SUB. TRUNNION FOR DRUM FILTER (DRIVE
SIDE)

DRG. NO. UCI/M-722/C

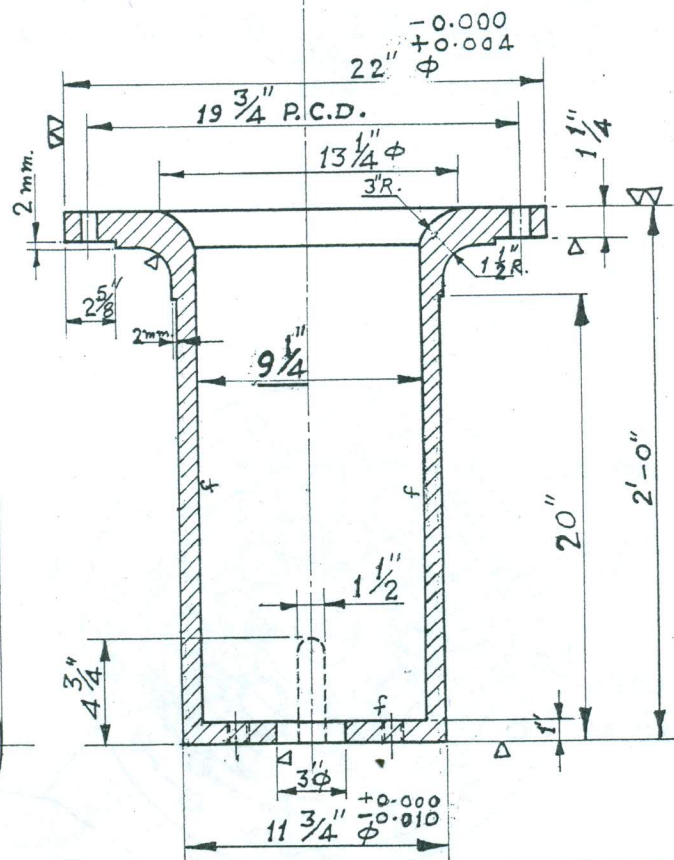
REV. 'A' $1" \phi$ & $2 \frac{1}{2}" \phi$ BSW TAP HOLES FOR JACKING. ADDED (MKSinghai)
27/6/05

4 NOS. $1" \phi$ BSW TAP HOLES
ON $19 \frac{3}{4}"$ P.C.D. (FOR JACKING)
